ENVIRONMENTAL RESTORATION PROJECT
COMMUNICATION RECORD

This communication record (including Attachment 1 and 2) documents the October 15, 2001 discussion between Vickie Maranville, NMED-HWB and Paula Bertino, LANL ER Project regarding LANL's request and NMED-HWB's approval to extend the submittal date for the Voluntary Corrective Measure (VCM) plan for PRS 21-024(i) from January 30, 2002 to March 30, 2002. To ensure the determination of the nature and extent of contamination associated with the former septic tank and to supplement the Interim Action (IA) Plan (LANL 1998, 58901.3) and the Field Implementation Plan (FIP) (LANL 2001, ER2001-0690) for this PRS, LANL will complete the collection of four confirmation subsurface soil/tuff samples from three sample locations directly south and to the east of the former location of the septic tank before October 30, 2001. However, due to the backlog remaining at offsite fixed analytical laboratories, results from these samples will not be received in time for evaluation and inclusion in a January 2002 deliverable. Inclusion of these sample results is essential to determine if a VCM plan is required or if an IA completion report is more app

Attachment 1
IA Confirmation Sample Locations at PRS 21-024(i)

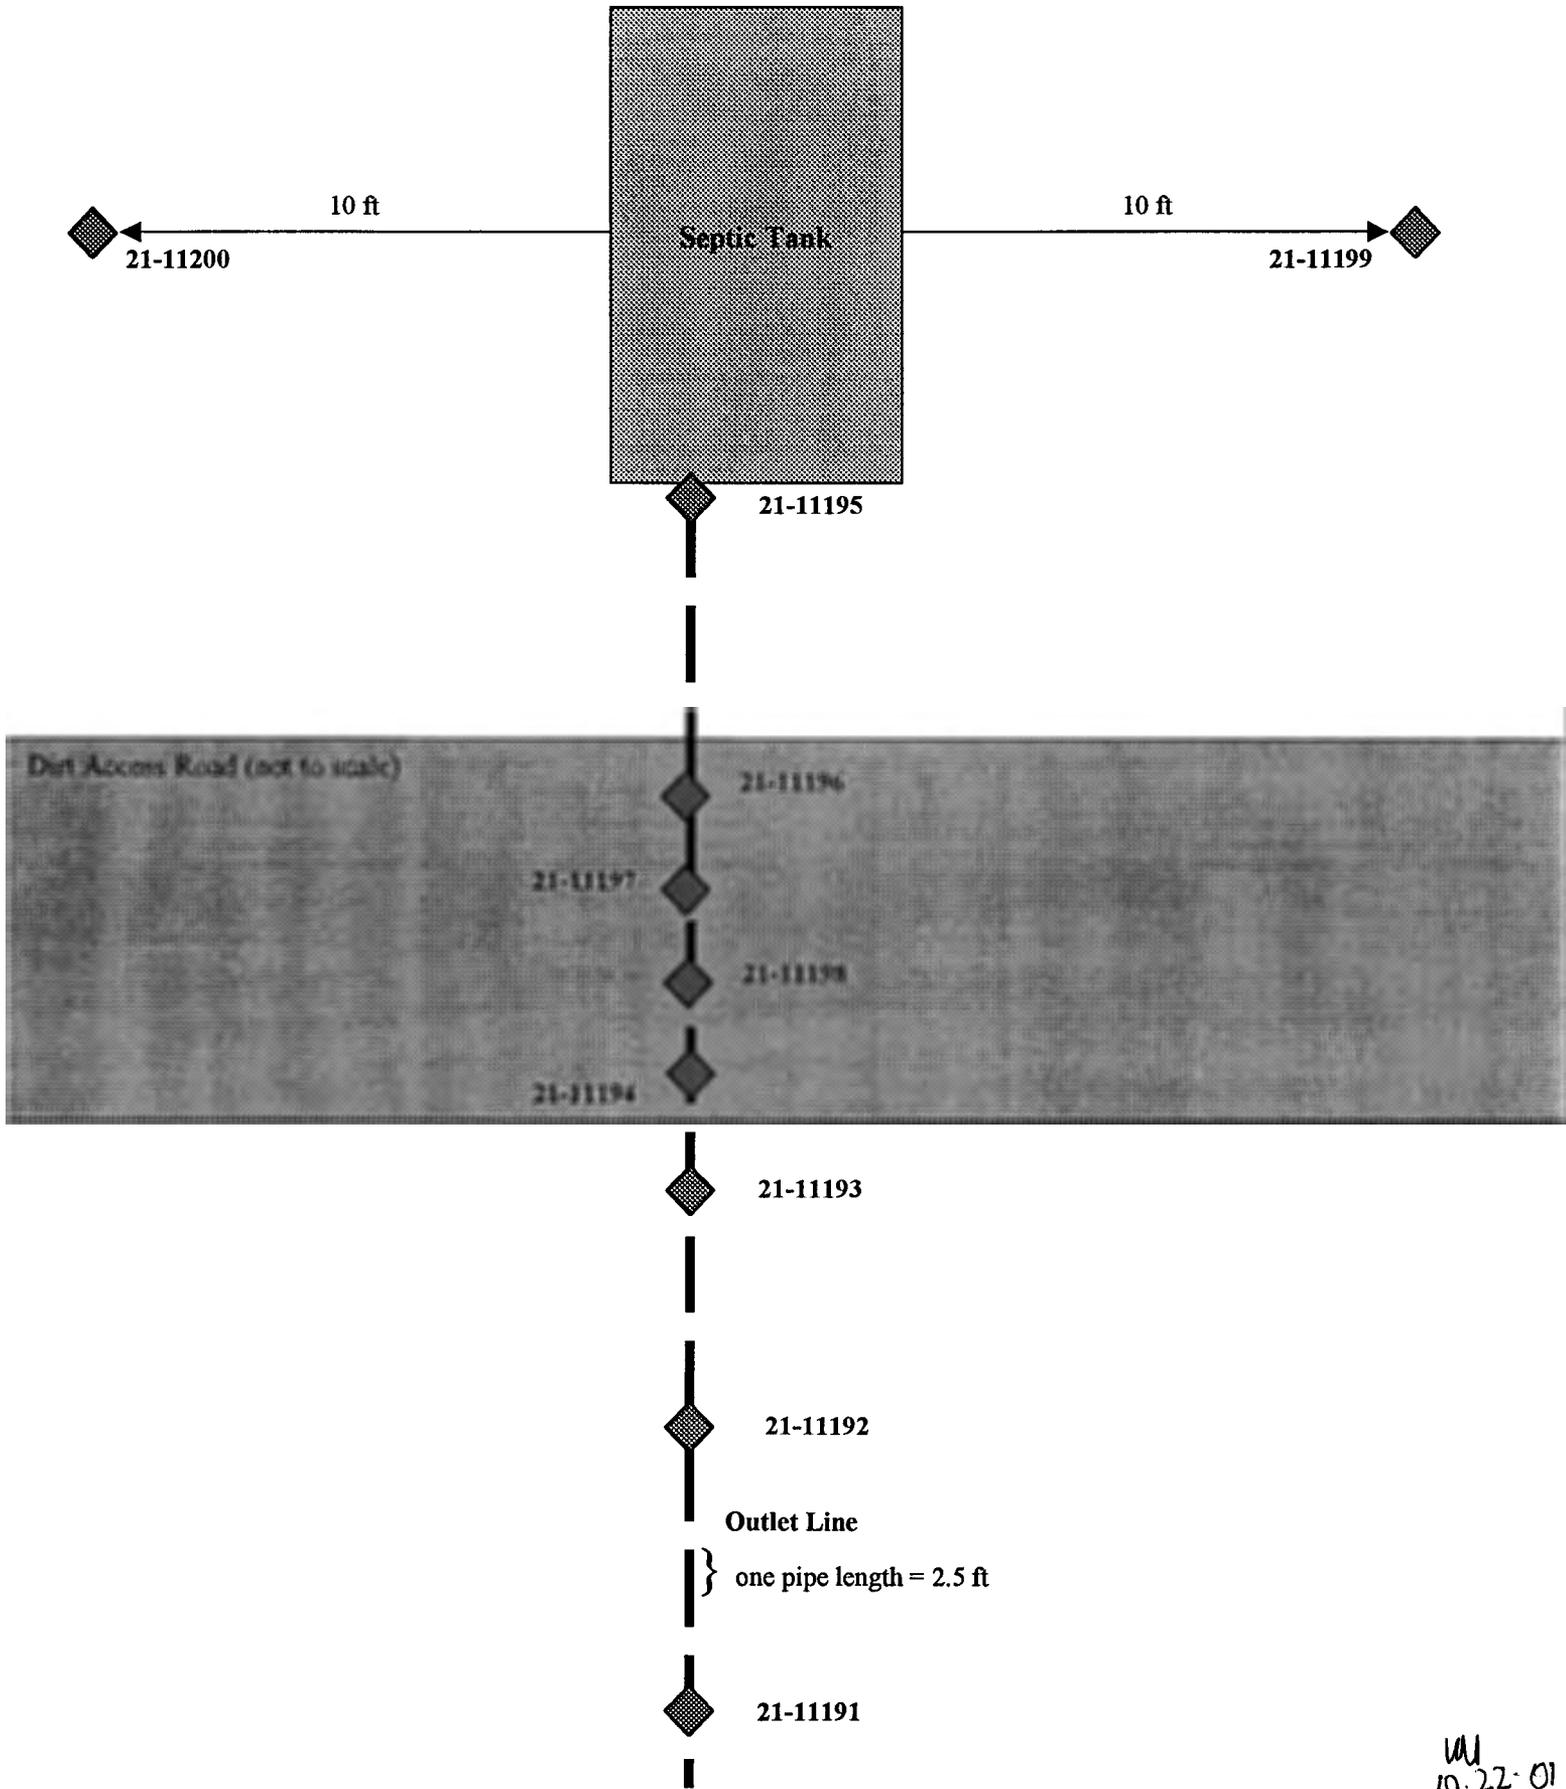
Attachment 1 shows the IA confirmation sample locations currently established outside the septic tank excavation at PRS 21-024(i). Attachment 2 describes the outstanding confirmation samples including the approximate sample locations, depth intervals, and analytical suite.

Figure 1. Locations of additional confirmation samples adjacent to former septic tank at PRS 21-024(i) (not to scale).

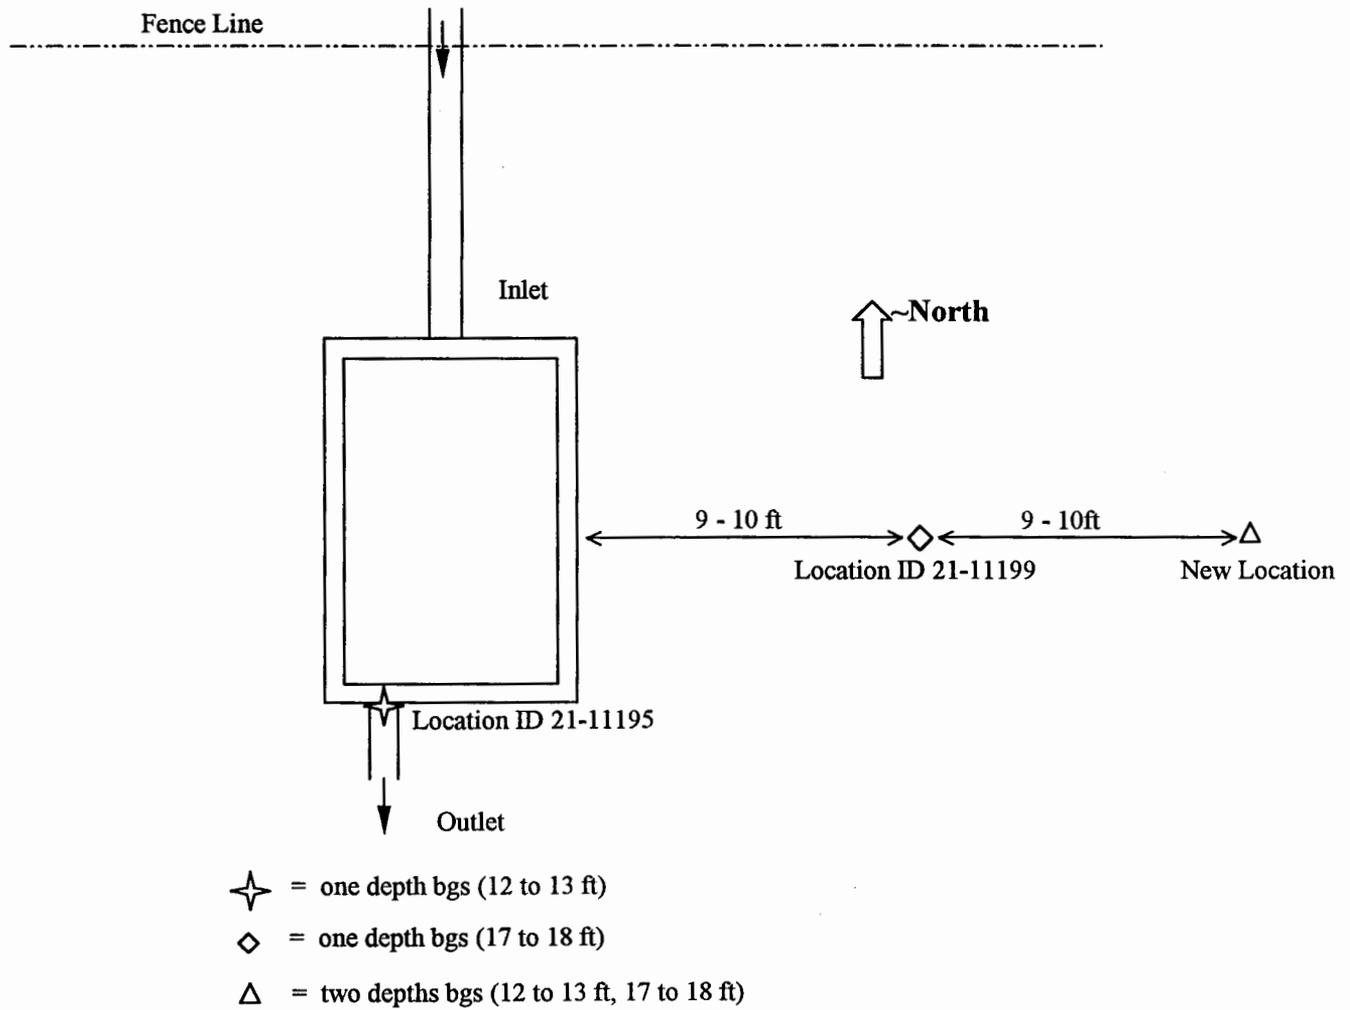
1.0 Tank and Outlet Line Junction (Location ID 21-11195) ✦

- Collect one confirmation sample from 12 to 13 ft. below ground surface (bgs) at this location.

2.0 Step-Out Location East of Septic Tank (Location ID 21-11199) ◇

- Collect one confirmation sample from 17 to 18 ft. bgs at this location, to make up for the sample that was missed due to refusal during the February 2001 sampling effort.

3.0 Additional Step-Out Location East of the Septic Tank △

- Identify additional step-out location approximately 10 ft east of sample location 21-11199.
- Collect confirmation samples from two depth intervals at this location:
 - 12 to 13 ft. bgs
 - 17 to 18 ft. bgs
